## Change Order Request

**Project:** 2410068-02  
City of Shakopee - SandVenture  
1101 Adams Street South  
Shakopee, MN 55379

**PCO #** 34 - SEH SI 07: Earthwork Changes

## Prime Contract Potential Change Order #007: CE #009 - Revised Water Plans per City

P401

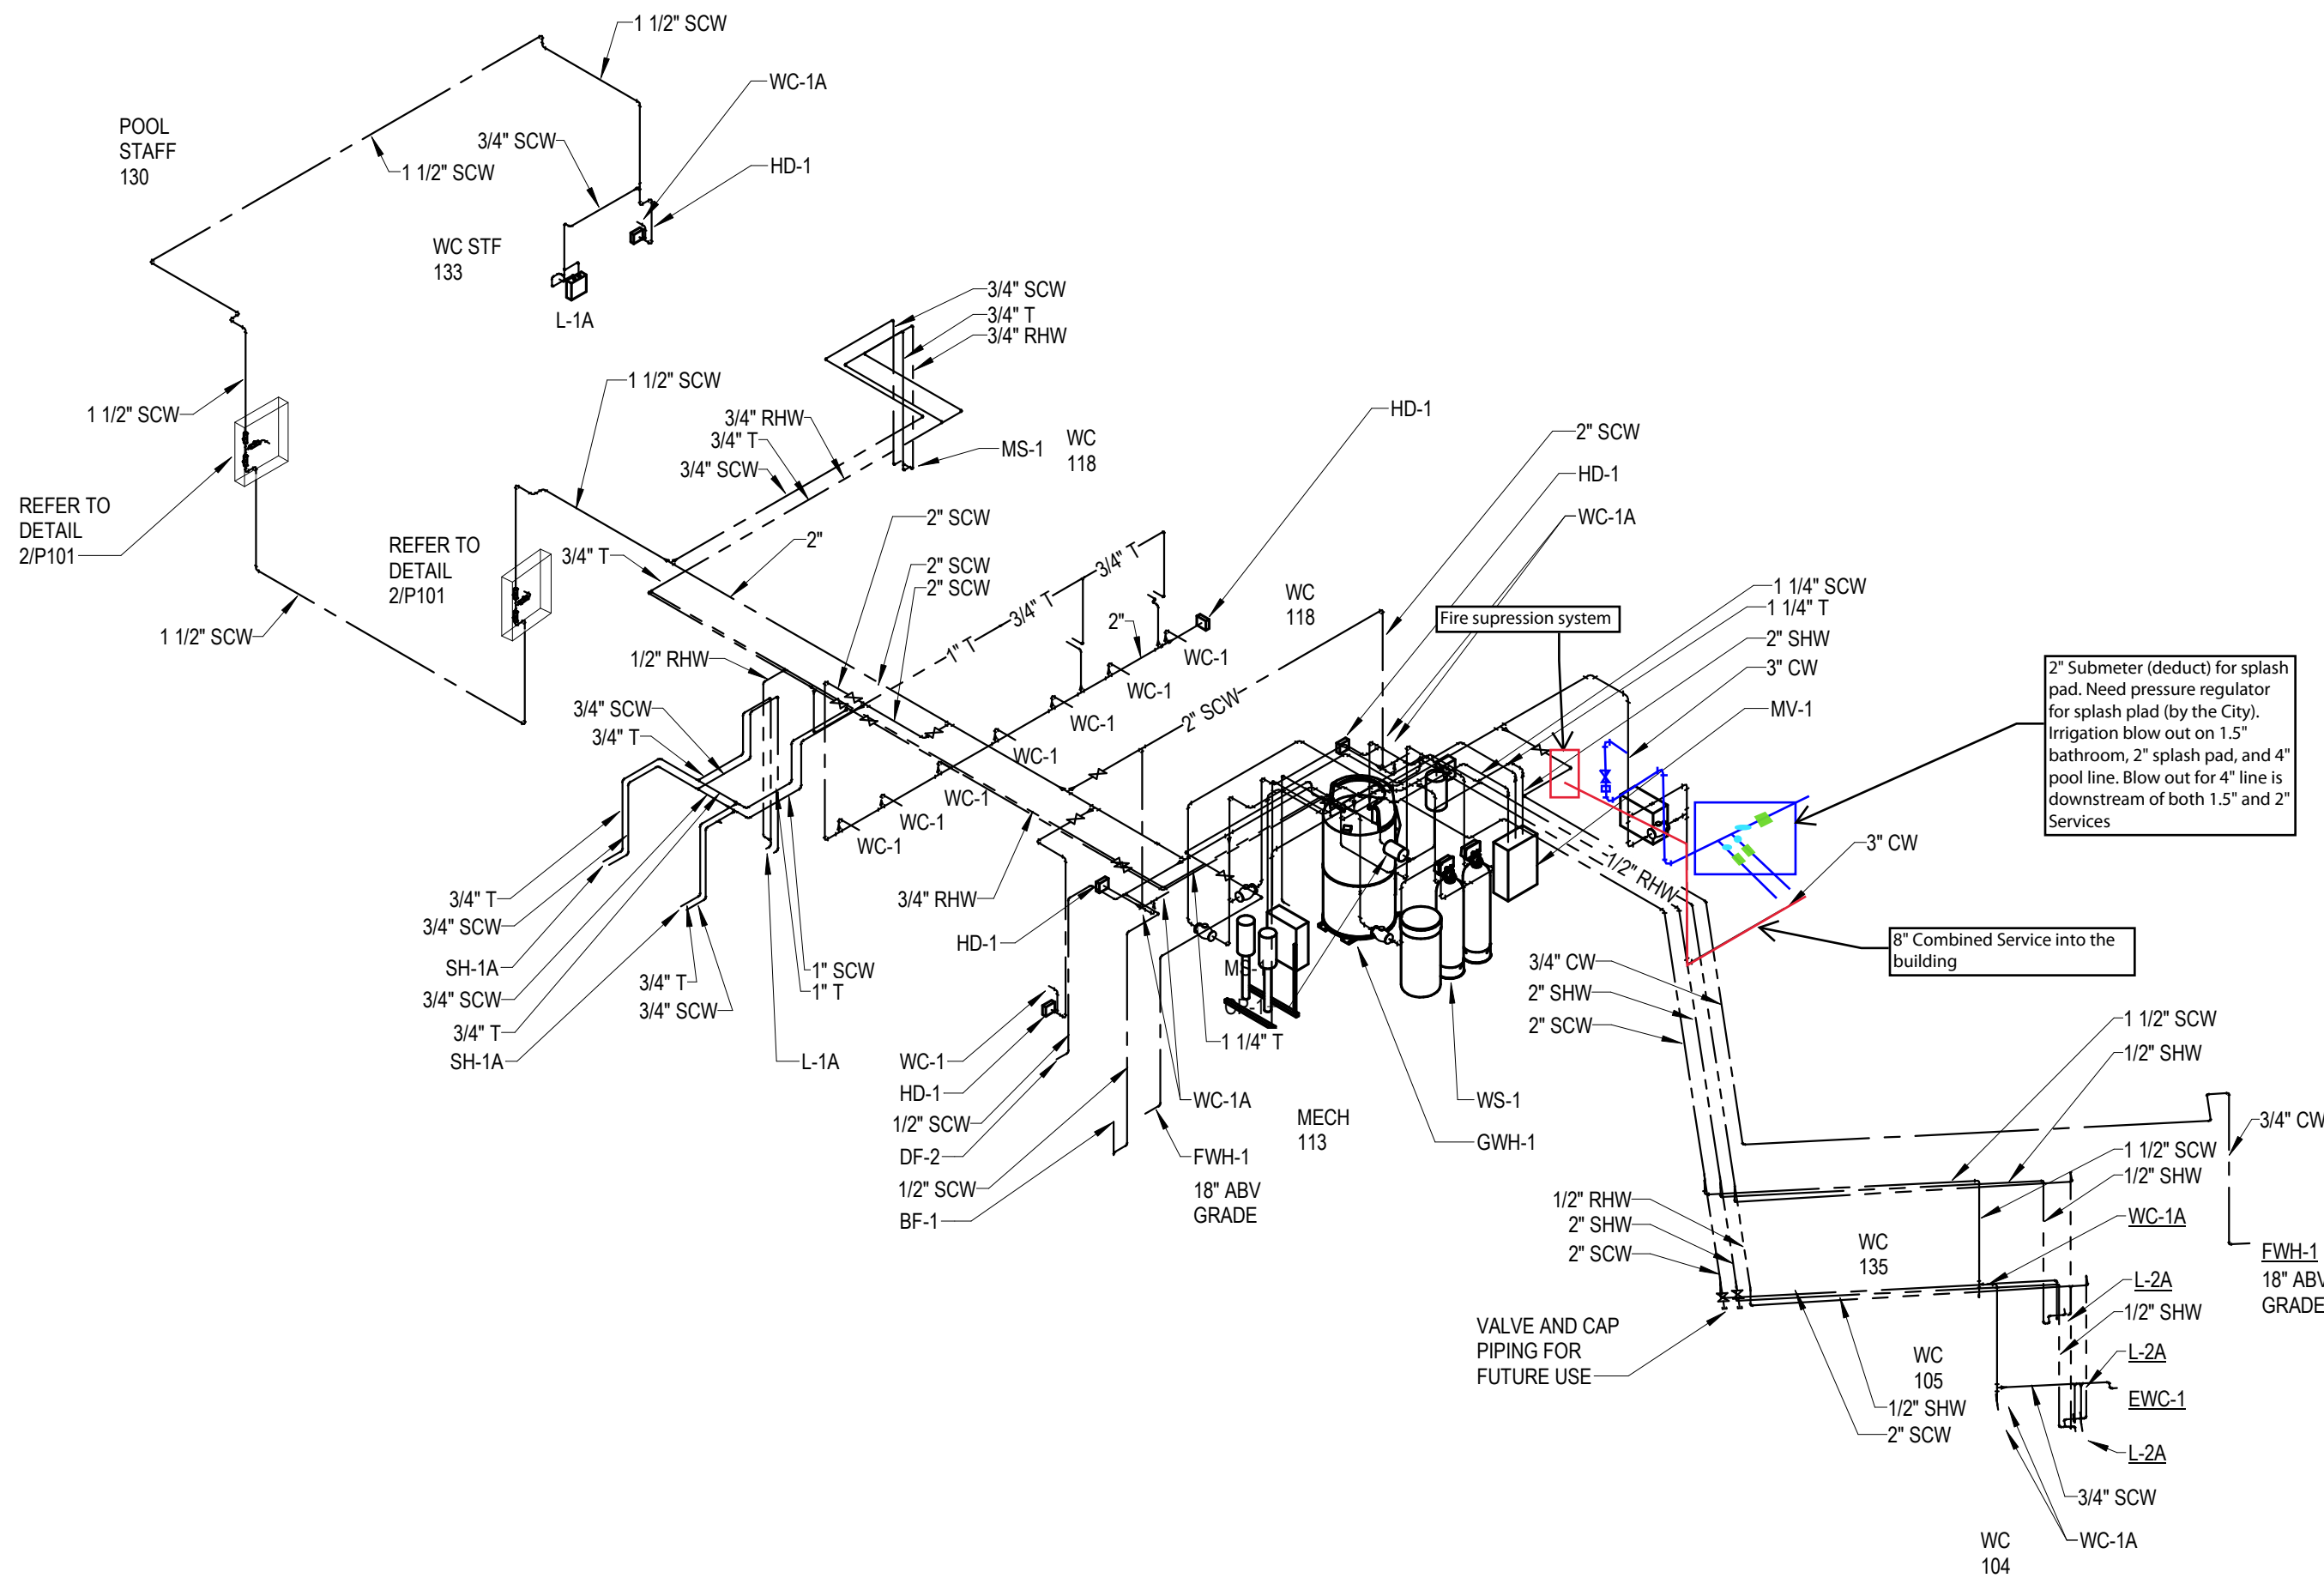
| Final Utility Design & K-A Scope |              |          |       |               |              |               |                                                                                                    |
|----------------------------------|--------------|----------|-------|---------------|--------------|---------------|----------------------------------------------------------------------------------------------------|
| Excavator w/ operator            | \$ 293.00    | 5.00     | HR    | \$ 1,465.00   | \$ 146.50    | \$ 1,611.50   | Remove 6" Riser and replace with 8" Riser. Old 4" fire riser to become new pump house supply riser |
| 8" Building Riser                | \$ 1,002.38  | 1.00     | EA    | \$ 1,002.38   | \$ 100.24    | \$ 1,102.62   | 8" Building Riser                                                                                  |
